29 August 2025

Comments on Birriwa Solar Modification, SSD-29508870-Mod-1, Barneys Reef Road, Birriwa, by ACEN Australia Pty Ltd, by Central West Cycle Trail Incorporated.

Barney's Reef Rd north of junction with Merotherie Rd (aka Slap Dash Creek Adventure Trail)
cycle track upgrades for avoiding
renewable energy traffic volumes on current CWC trail

Figure 1: Route 1 leads to from Merotherie Rd 4km south of Golden Highway to Energy Hub, Route 2 leads to ACEN's accommodation, and Route 3 leads from ACEN accommodation to Merotherie Rd.

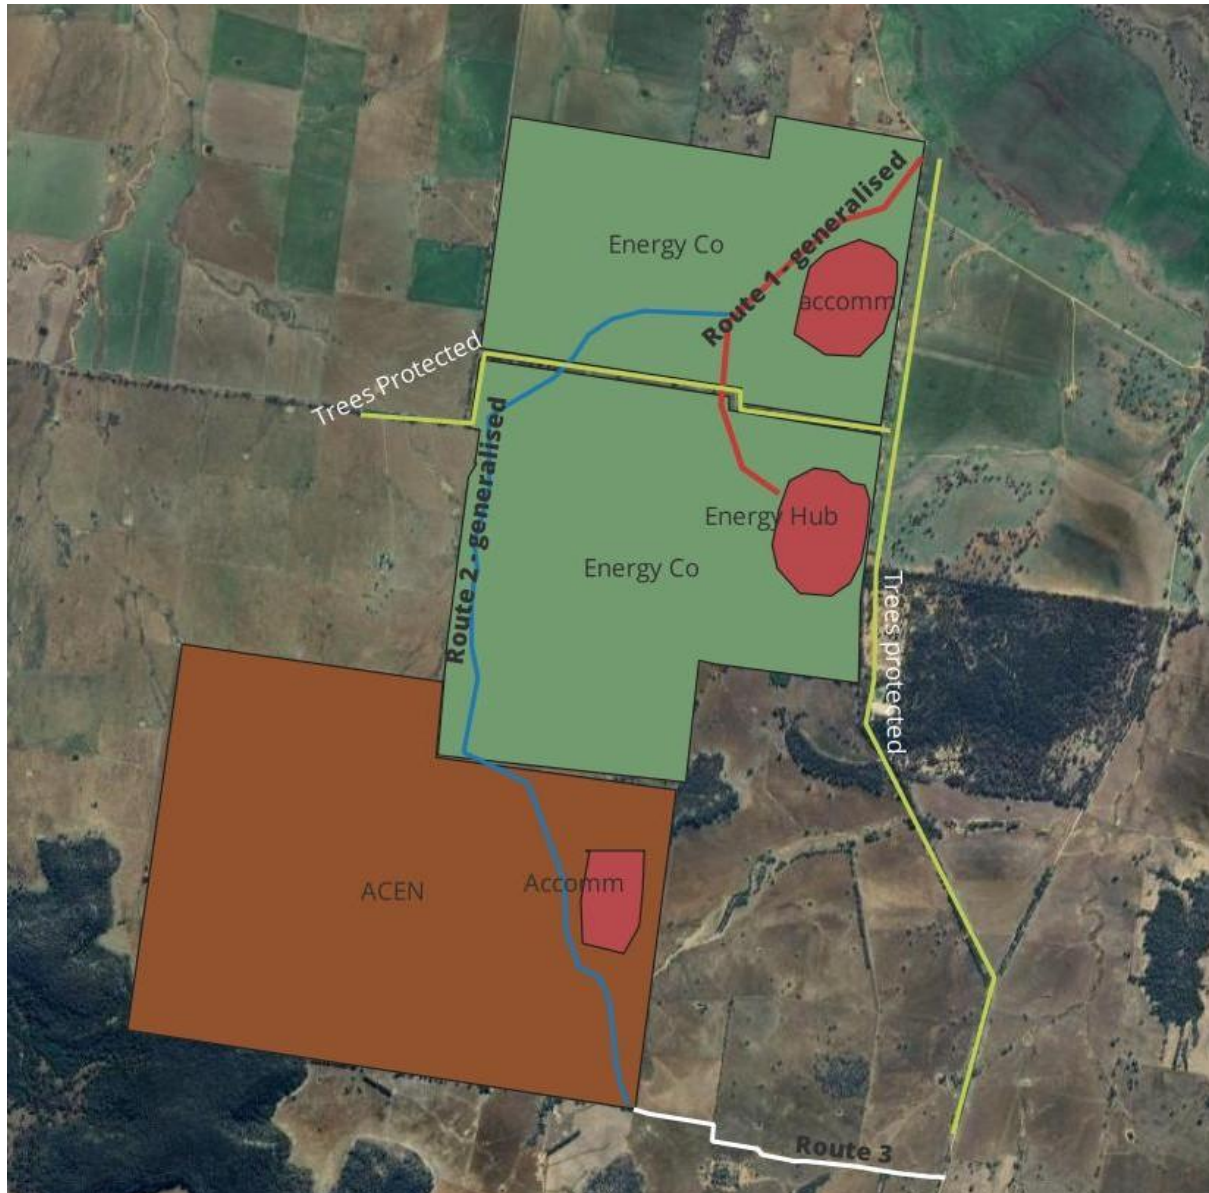
We believe that alternatives to this felling of trees exist. Our proposed alternative routes are shown on Figure 1. We are not privy to all property ownership moves and landholder agreements, so this is a concept plan that needs concrete detail for implementation. Our plan is broadly that roads required for the access to accommodation camps, energy hub and solar arrays should be brought onto cleared agricultural land. Much of the land required is already or will be owned by Energy Co or ACEN.

The overall concept of our alternative is shown in the accompanying map, and if fully implemented would protect close to 9km of roadside vegetation. The following points are important:

1. Energy Co owns land from 4km south of the Golden Highway and hence is readily positioned to implement Route 1 shown, which would protect 1.8km of roadside vegetation.
2. Energy Co must co-operate with ACEN to give access for the construction of Route 2, which will allow ACEN to avoid clearing along 3.4km of Birriwa Bus Route South. ACEN is keen for to be able to use Energy Co land for access.
3. Route 3 allows ACEN to use 3.5km of Merotherie Rd to access its Narragamba Solar Project. Route 3 has the issue of 250 metres of box-gum woodland mature trees if the current Crown

road alignment is followed. Discussions are needed with the adjacent landholders to see if some land swap arrangement could be reached.

Figure 1: Barney's Reef Rd from junction with Merotherie Rd to Birriwa Bus Route South.

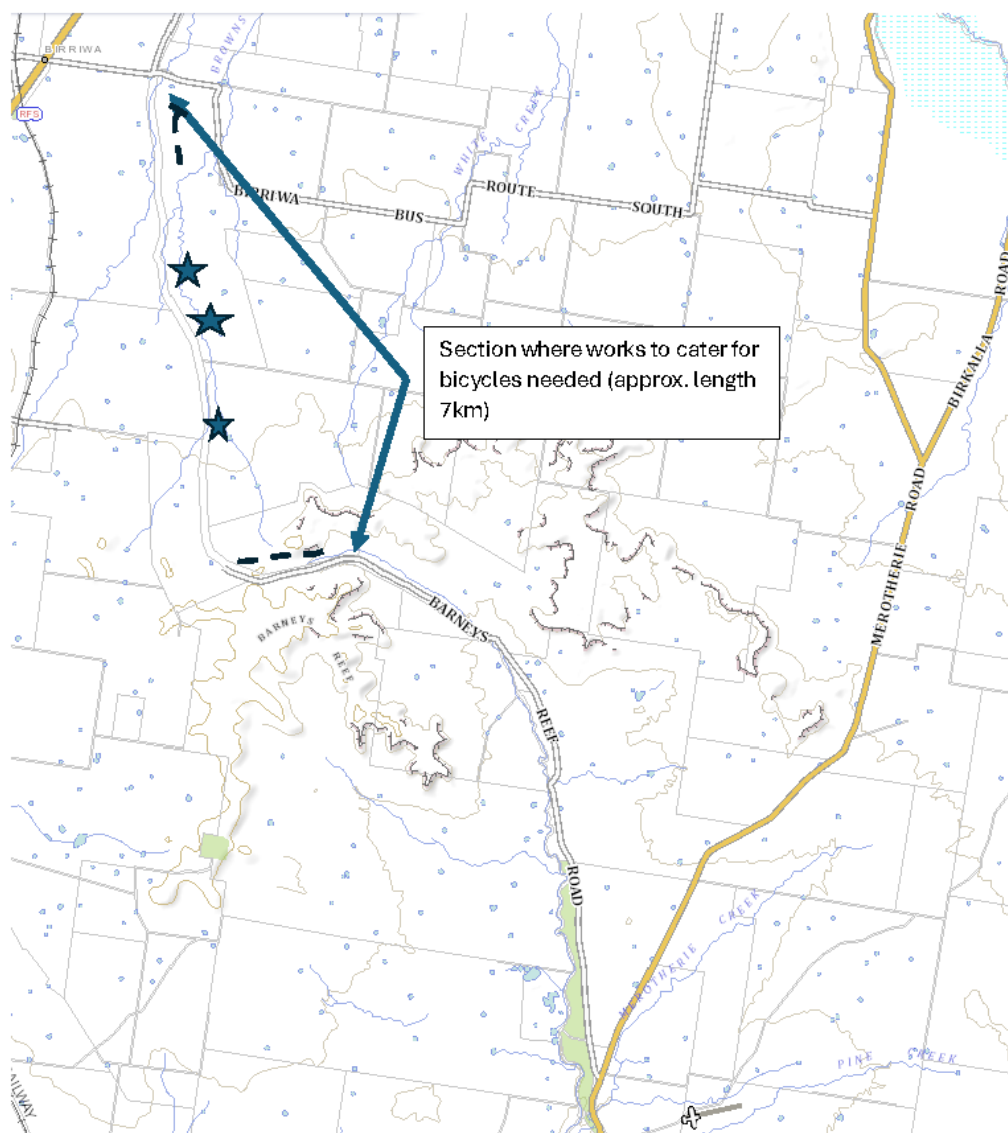
1. 750m of grading and installation of cross drains from the crest of Barney's Reef range north,
2. Culverts installed in 3 creek crossings with narrow concrete track to top of embankment. In one creek crossing the option of an expanded metal walkway/cycle bridge of 7 to 10m length should be considered,
3. A raised gravel bicycle track (0.2 to 0.3m height) over 450m of seasonally boggy area, and
4. Slashing of existing track which provides a very sound smooth surface for cycling.

Figure 1 shows the general location of works and Figure 2 outlines the construction works needed at each location.

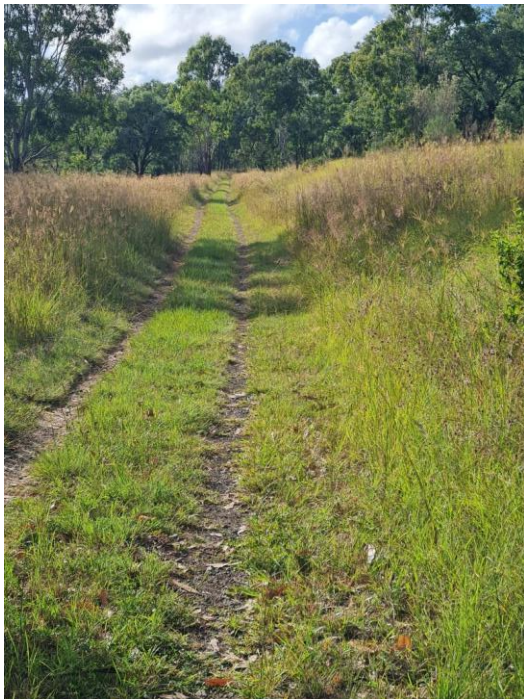
From km 8.9 to km 9.5 there is steep section of track which is eroded and has loose gravel. Track has a slope of 5% to 10%. **Grading and installation of cross drain needed to prevent future erosion.**
